From: BRYAN Martin (EXTERNAL AREVA) [Martin.Bryan.ext@areva.com]
Sent: Friday, January 28, 2011 11:27 AM
To: Tesfaye, Getachew
Cc: DELANO Karen (AREVA); ROMINE Judy (AREVA); BENNETT Kathy (AREVA); KOWALSKI David (AREVA); BALLARD Bob (AREVA); WILLIFORD Dennis (AREVA); HALLINGER Pat (EXTERNAL AREVA); HAYS Lynn (AREVA); GARDNER Darrell (AREVA); PATTON Jeff (AREVA)
Subject: DRAFT Response to U.S. EPR Design Certification Application RAI No. 345, FSAR Ch. 9, question 9.2.1-39
Attachments: RAI 345 Supplement 11 Response US EPR DC - DRAFT.pdf

Subject: DRAFT Response to U.S. EPR Design Certification Application RAI No. 345,
FSAR Ch. 9, question 9.2.1-39
Sent Date: 1/28/2011 11:27:00 AM
Received Date: 1/28/2011 11:27:38 AM
From: BRYAN Martin (EXTERNAL AREVA)

U.S. EPR Final Safety Analysis Report Markups

Figure 9.2.1-1—Essential Service Water System Piping & Instrumentation Diagram
Sheet 2 of 4

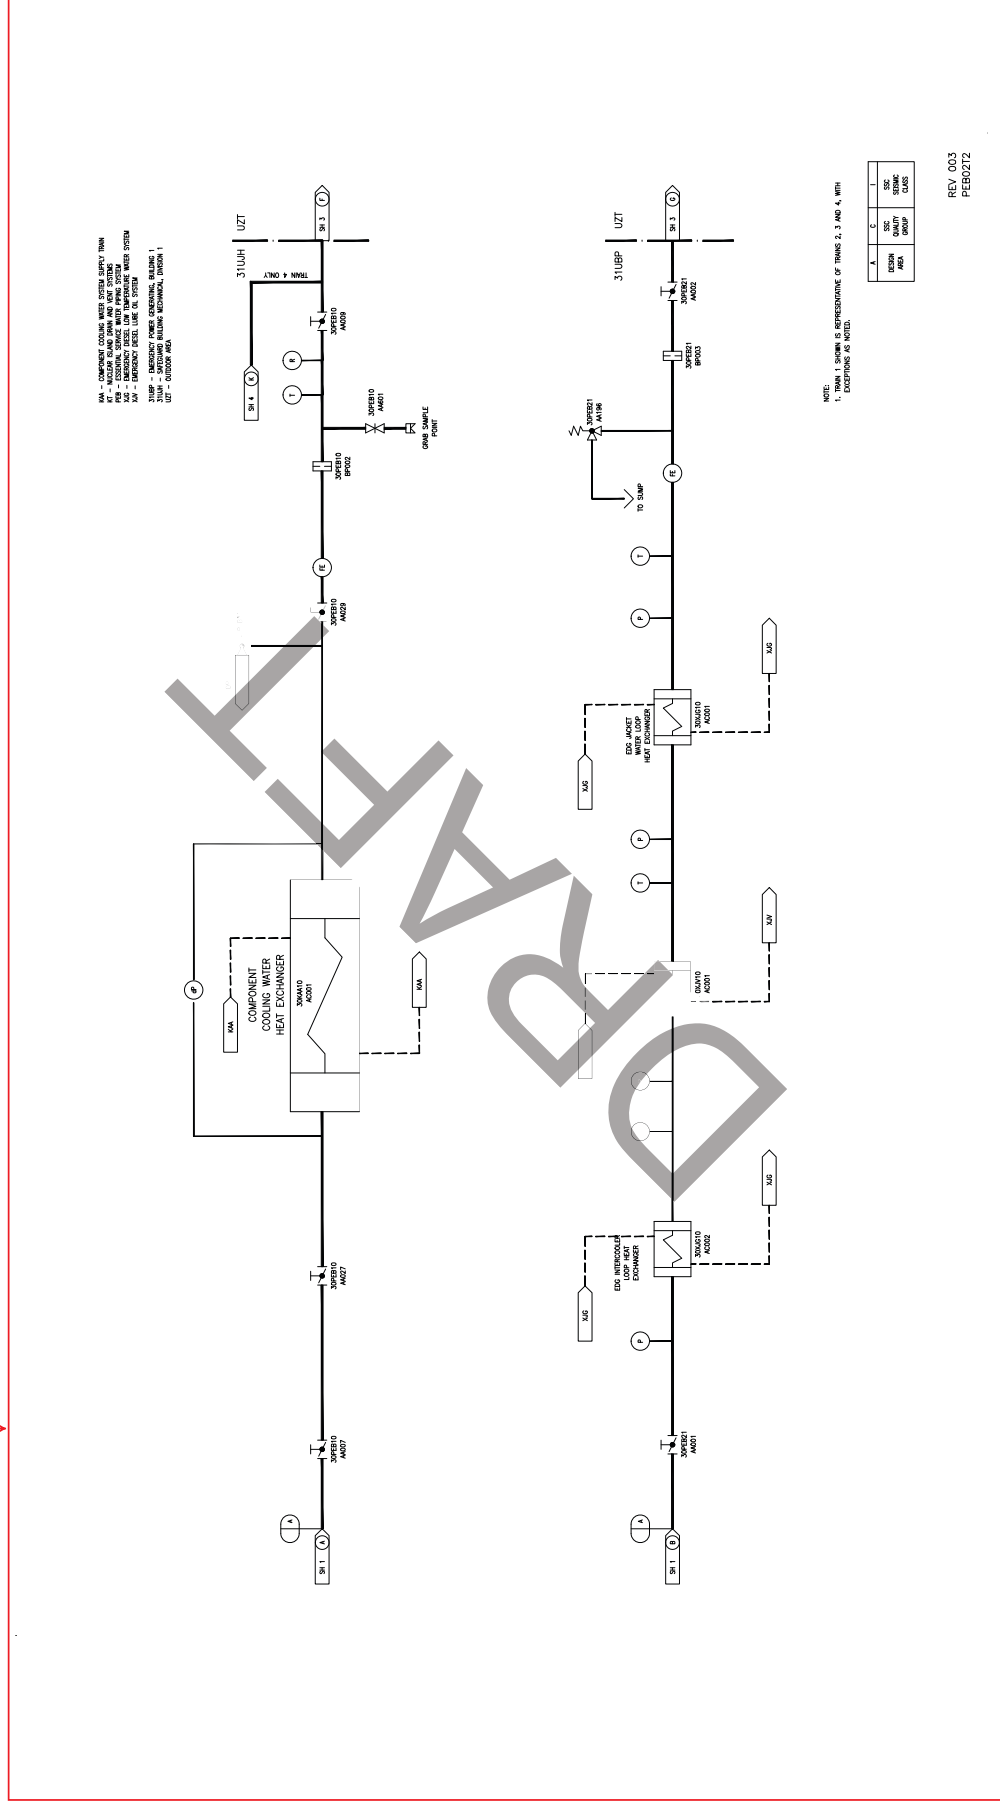
09.02.01-39

Figure 9.2.1-1—Essential Service Water System Piping & Instrumentation Diagram
Sheet 4 of 4

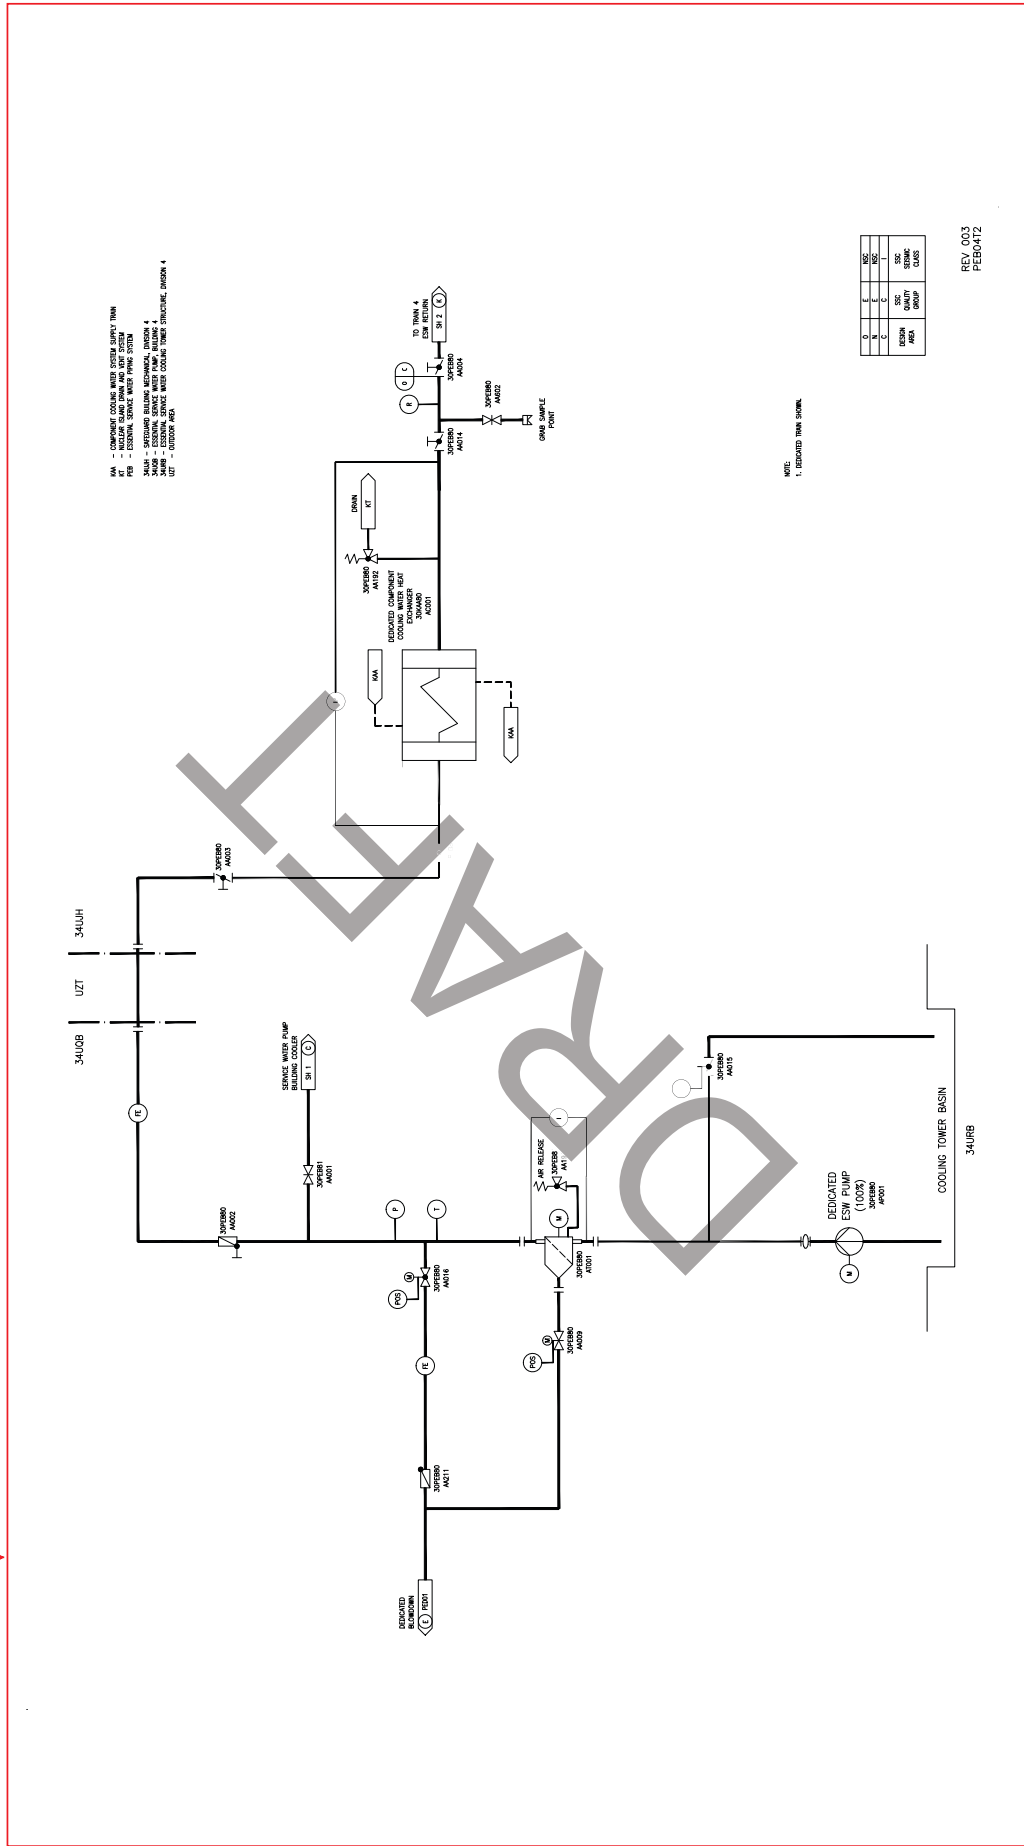
09.02.01-39

Figure 11.5-1—Radioactive Effluent Flow Paths With Process and Effluent Radiation Monitors

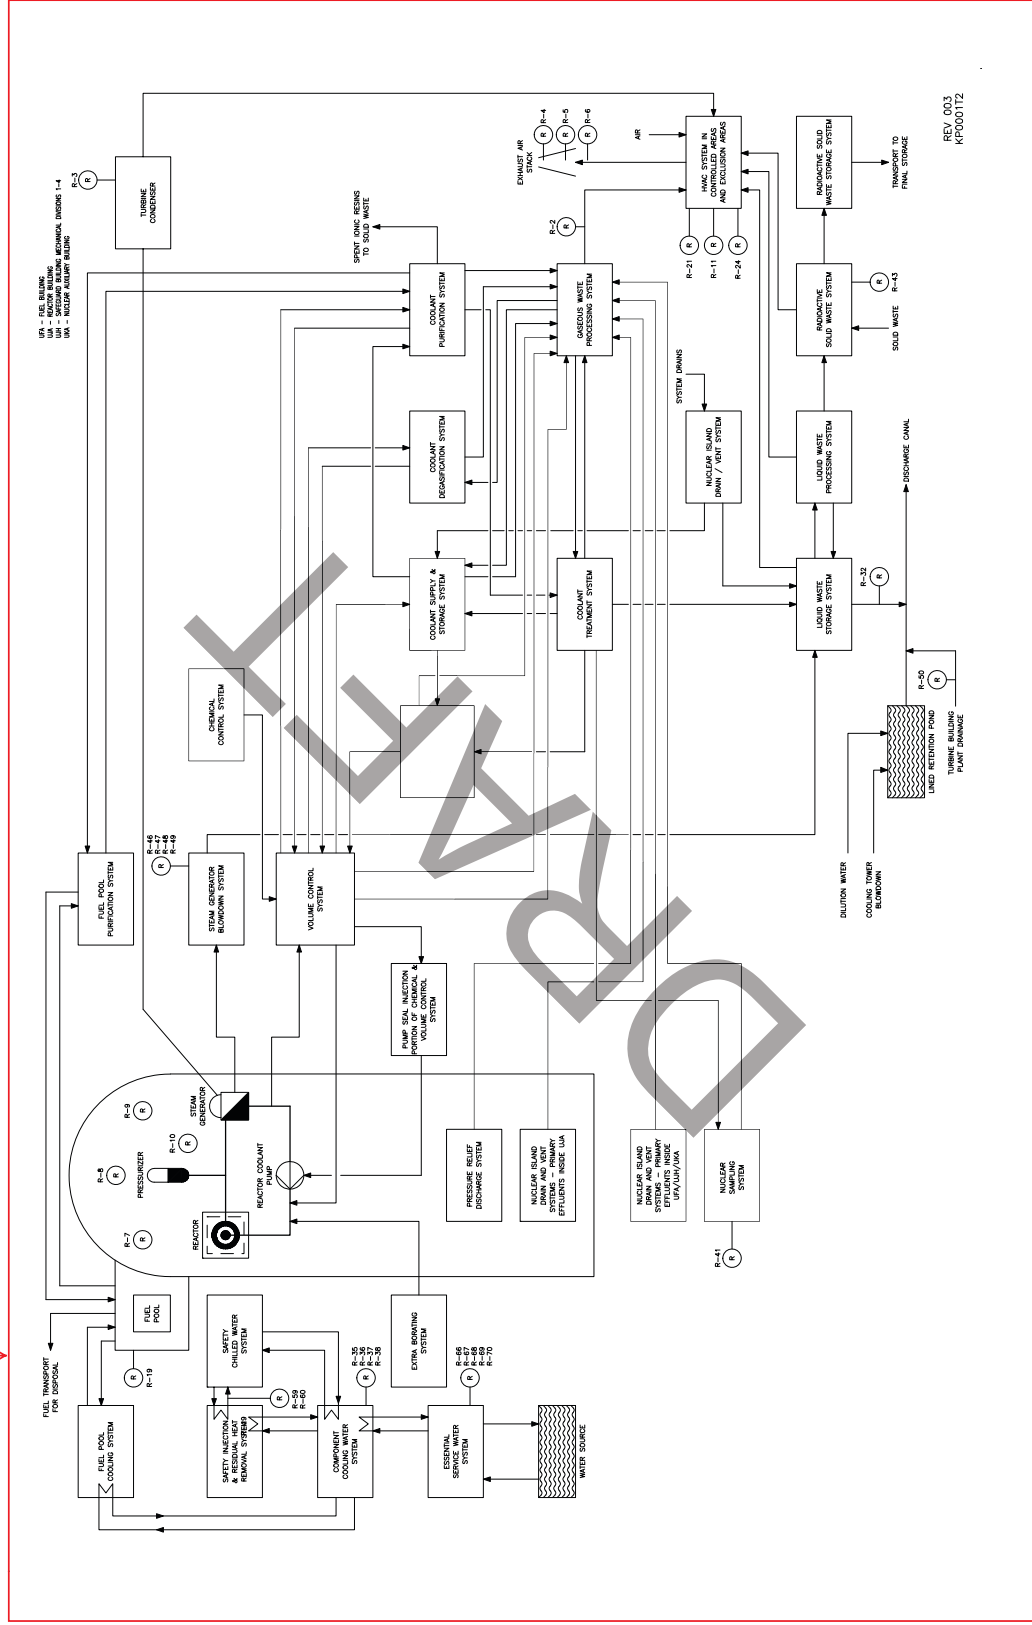
09.02.01-39
